Sydney Olympic Park New High School

SSDA Architectural Design Report

Amendment Report Addendum

Level 05 Floor Plan Comparison

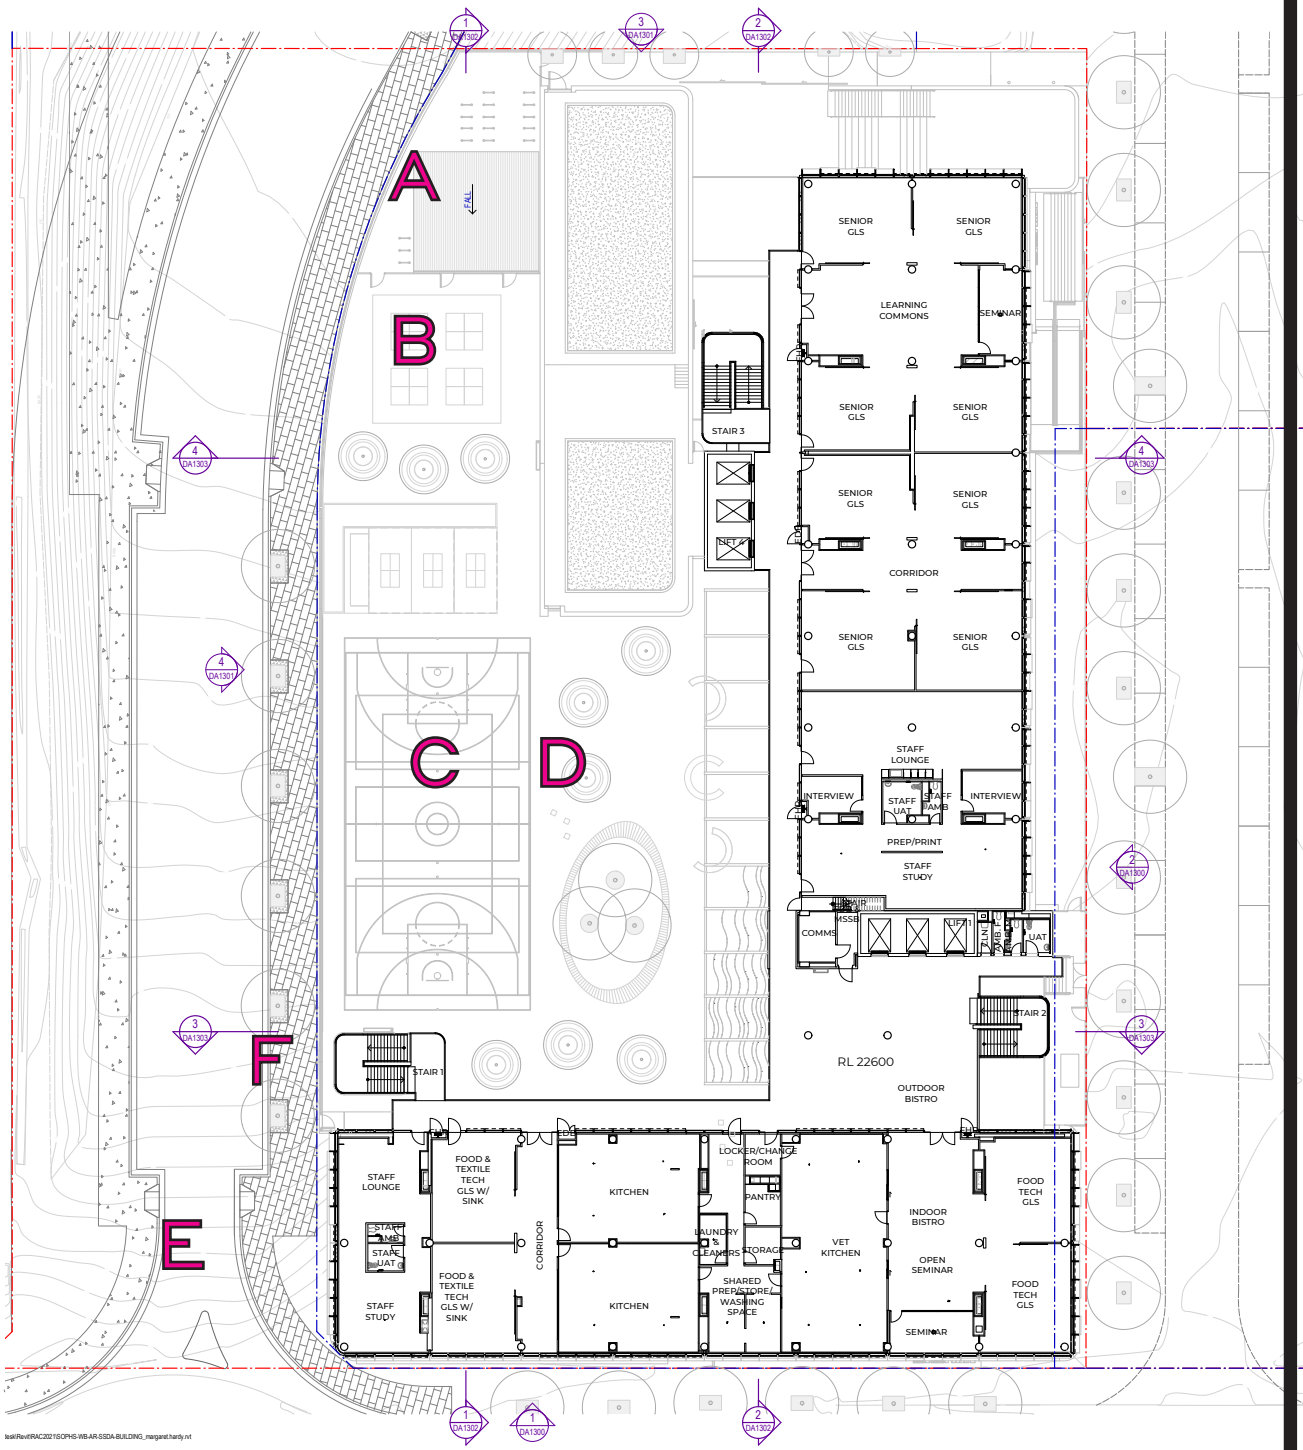
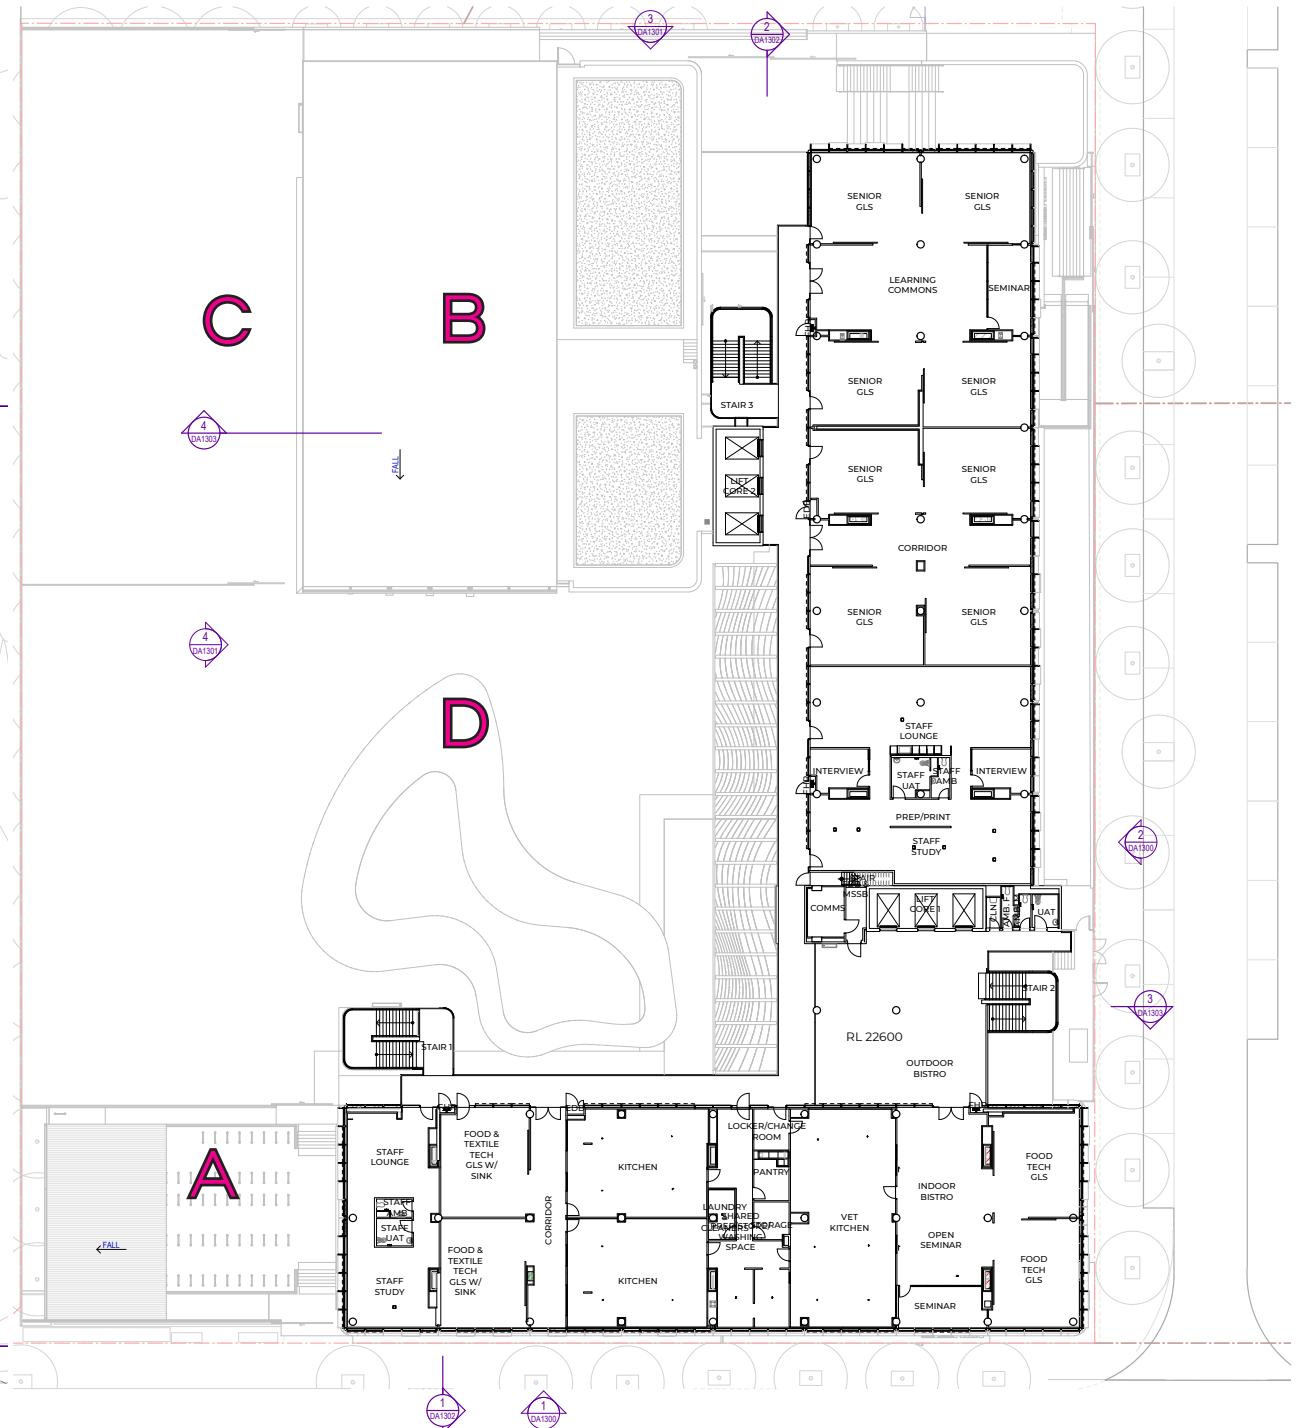
- A** Bike parking relocated
- B** Ground floor hall removed - relocated to Level 1
- C** External multi-purpose court - reduced to 1 and relocated
- D** Courtyard redesign, canopy omitted
- E** Ridge Road added
- F** Additional egress added to Ridge Road

Roof Plan Comparison

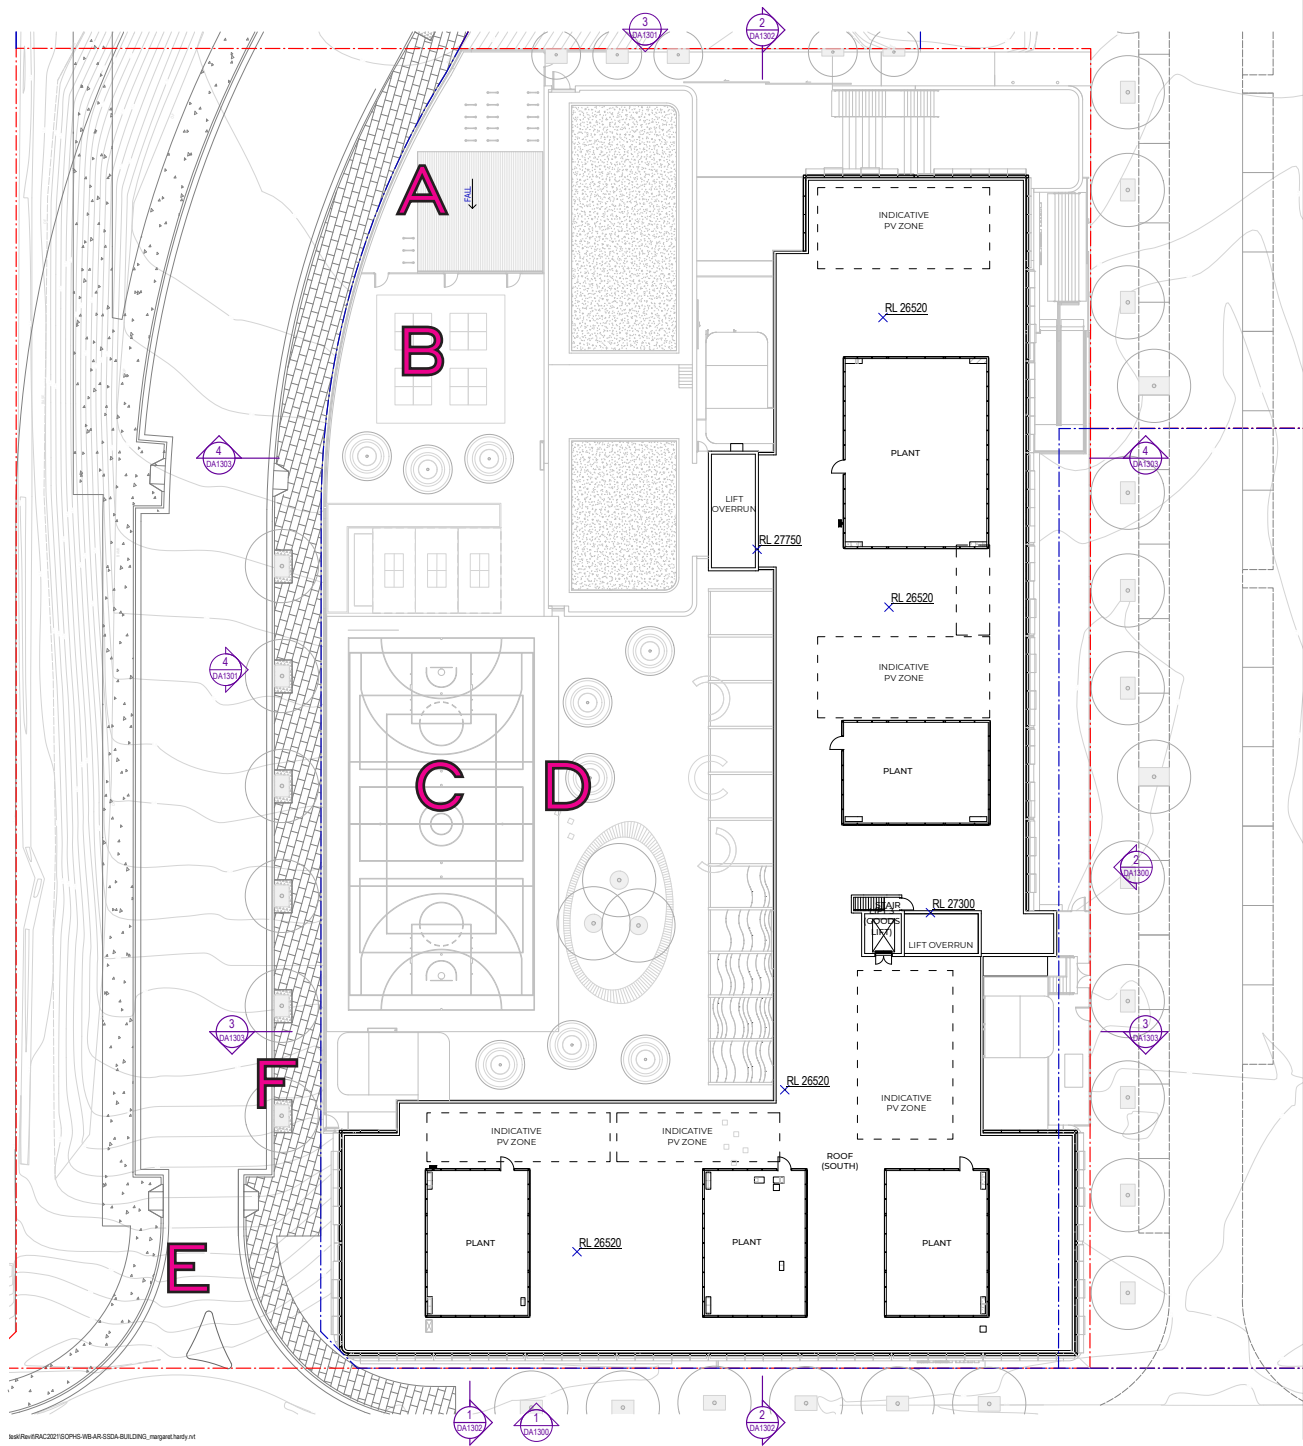
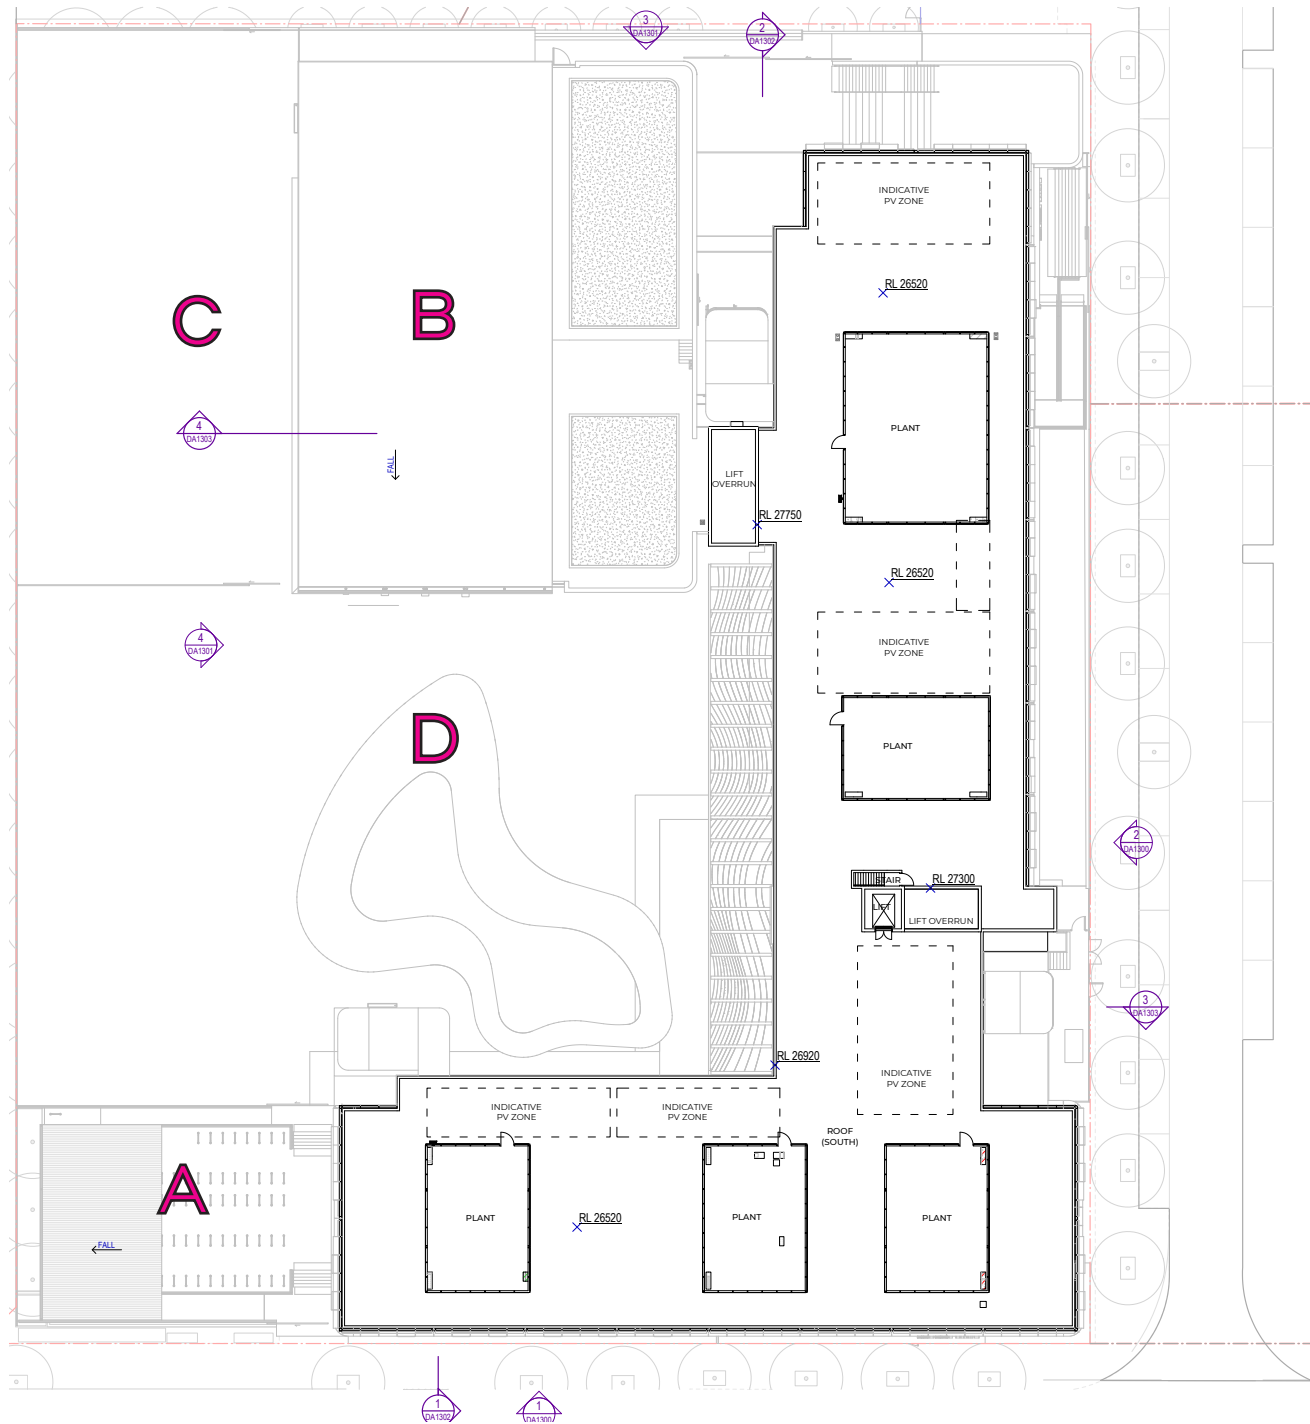
- A** Bike parking relocated
- B** Ground floor hall removed - relocated to Level 1
- C** External multi-purpose court - reduced to 1 and relocated
- D** Courtyard redesign, canopy omitted
- E** Ridge Road added
- F** Additional egress added to Ridge Road
